U.S. Steel – Minntac Tailings Basin CCM Summary

Clean Water Act Inspection Report
U.S. Steel - Minntac Tailings Basin Area Facility

Figure 12. EPA Sample Results (TDS/TSS, Sulfate, Specific Conductivity)

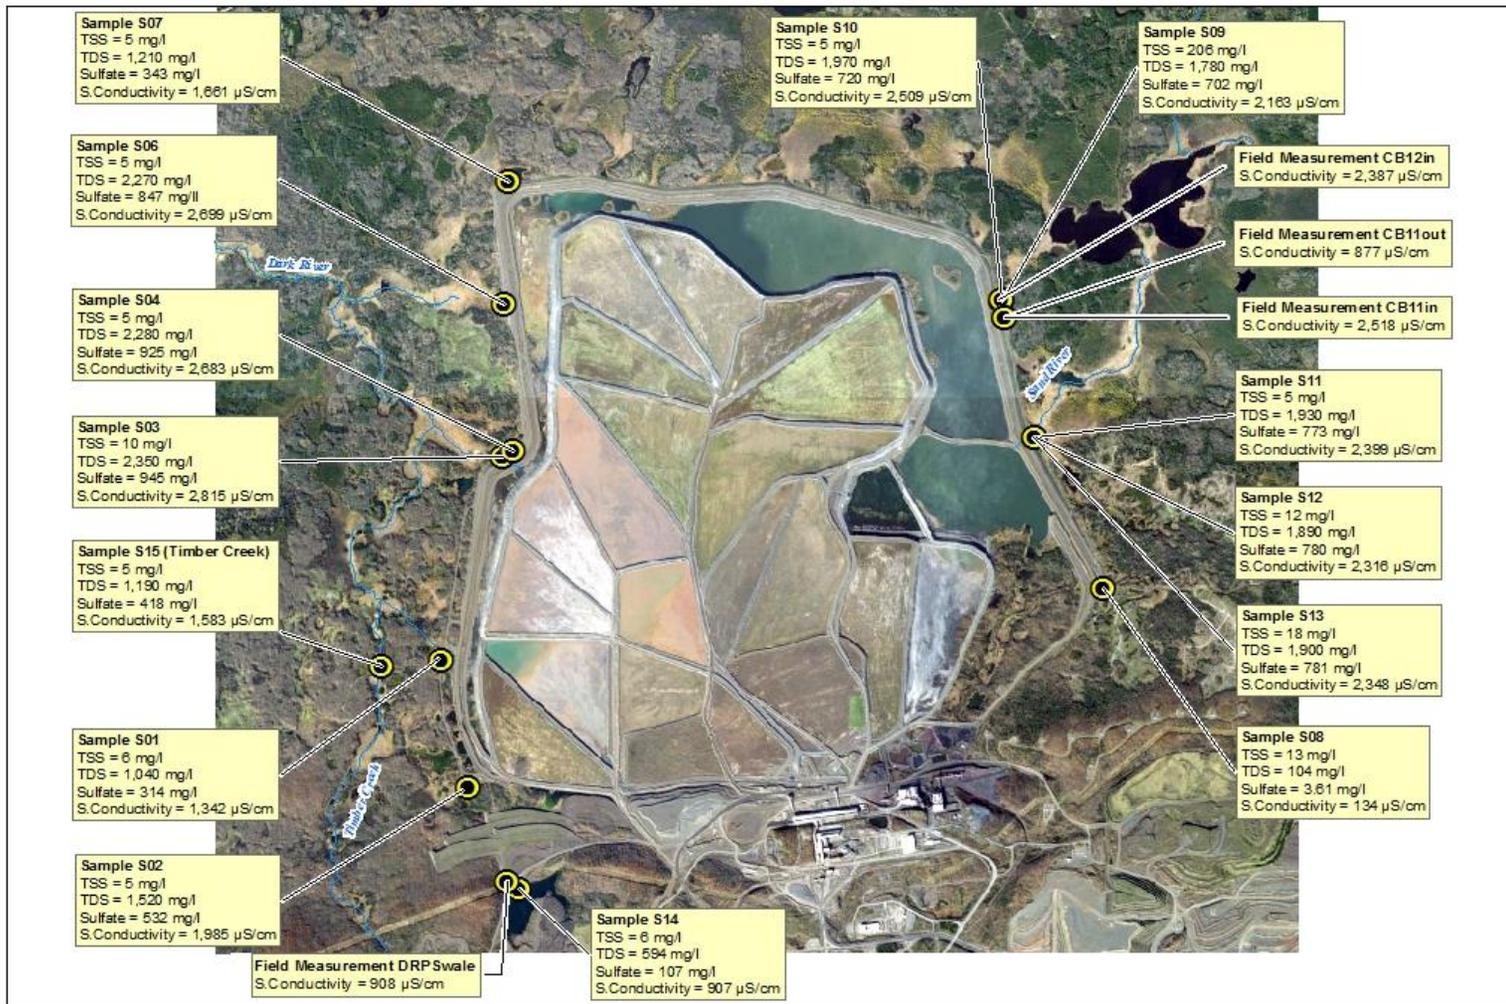
Wastewater Discharging Through and Under Tailings Basin Containment Dike [SNC]	<ul style="list-style-type: none"> • NPDES permit authorizes and sets effluent limitations for seep discharges from outfalls 020 and 030 only. • Results confirm elevated levels of multiple pollutants, including sulfate, at Tailings Basin perimeter dike surface water seep discharge locations [S01, S02, S03, S04 (formerly Outfall 020), S06, S07, S09, S11, and S13], when compared to the USS background area sample location (S08). • Elevated levels of multiple pollutants, including sulfate, exist in wetlands adjacent to the SC&R seep containment system, and surface waters adjacent to the east and west Tailings Basin dikes. • Seeps to surface water occur “along the perimeter dike due to: 1) the elevated water levels in the Tailings Basin pools, and 2) the permeability of the perimeter dike allows sporadic surface seeps along the toe of the dike.” (CRA, 2013a). • EPA sampling results indicate additional Tailings Basin seep discharges to wetlands in Township 59N, Range 18W, Sections 6, 7, 10, 15, 19, 24, 30, and Timber Creek. The permit does not mention seep discharges to wetlands in these sections or to Timber Creek, and does not authorize or set effluent limitations for these seep discharges.

Pollutants Bypassing SC&R Containment [SNC]	<ul style="list-style-type: none"> • Elevated levels of multiple pollutants, including sulfate, exist in wetlands adjacent to the SC&R seep containment system. USS modeling suggests the presence of elevated levels of pollutants, including sulfate, in wetlands adjacent to SC&R containment structure, is the result of pollutant particles moving downward from the shallow overburden into the deep overburden and passing “under the sheet-pile wall, which extends through the shallow overburden only. The particles then move upwards back into the shallow overburden before discharging to the wetland area.” (CRA, 2013b; Appendix G)
Source of Wastewater Not Identified in Permit	<ul style="list-style-type: none"> • USS representative identified the Dark River Pond as a source for Seep C. The permit does not mention the Dark River Pond in its description of sources of wastewater.
